## CHANGE ORDER

Project Number	62210538	
Project Title	Perimeter Fence Upgrades	
Change Order No:	1 Date of Issuance:	October 3, 2022
Ordinance No:	220301 Ordinance Effective Date:	May 1, 2022
	Contract Notice To Proceed Date:	July 5, 2022

Project No. & Title 62210538 Perimeter Fence Upgrades Change Order No. 1

PERIMETER FENCE UPGRADES

FENCE REPLACEMENT SITE PLAN SHEET 12 OF 20 skyl skyl REHABILITATION RELEASED FOR BID

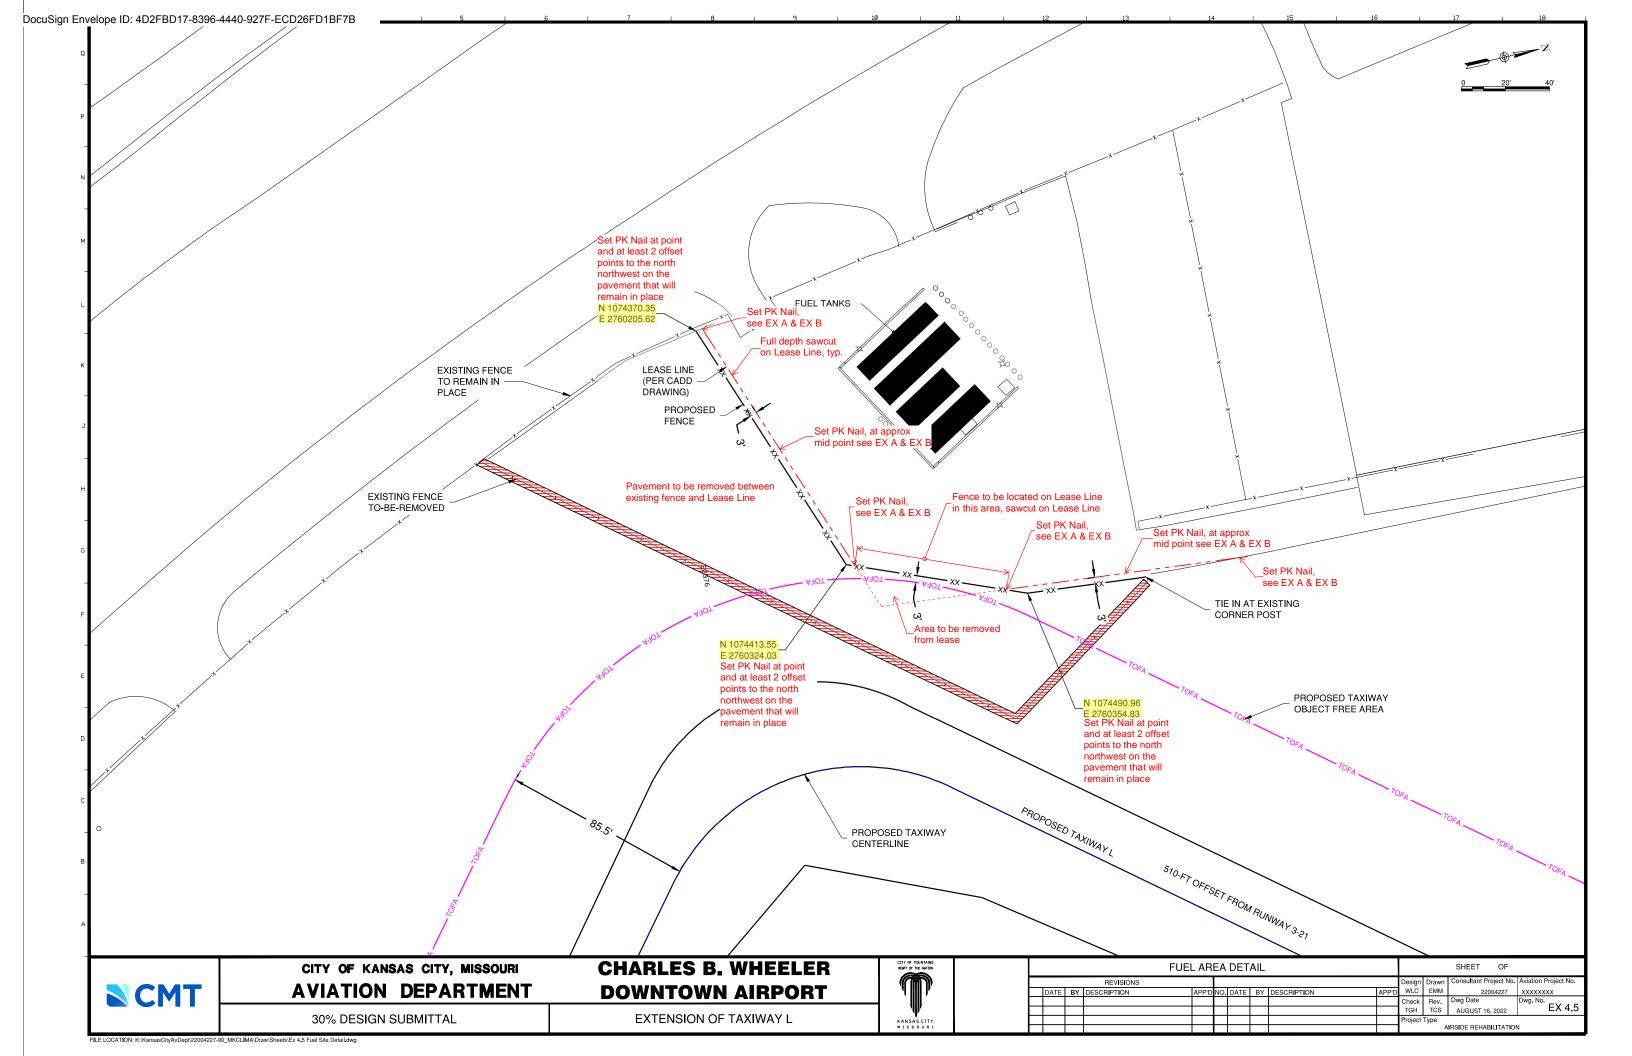
The Contract is changed as follows: Extend fence removal and replacement limits on the south end of the airport from Sta 227+09 to Sta. 232+19. At Pump House – Sta. 400+00 to Sta. 401+20, and at Airline History Museum, Sta. 300+00 to Sta. 302+80 in these areas, remove fabric, leave existing post in place, extend post as necessary, install new fabric and barbed wire. At Signature Flight Services Fuel Farm, existing fence shall be removed, existing pavement will be removed to the new lease line. New fence will be installed along lease line and 2 new automatic gates will be installed. Federal Supplementary Provisions are also being added to the contract.
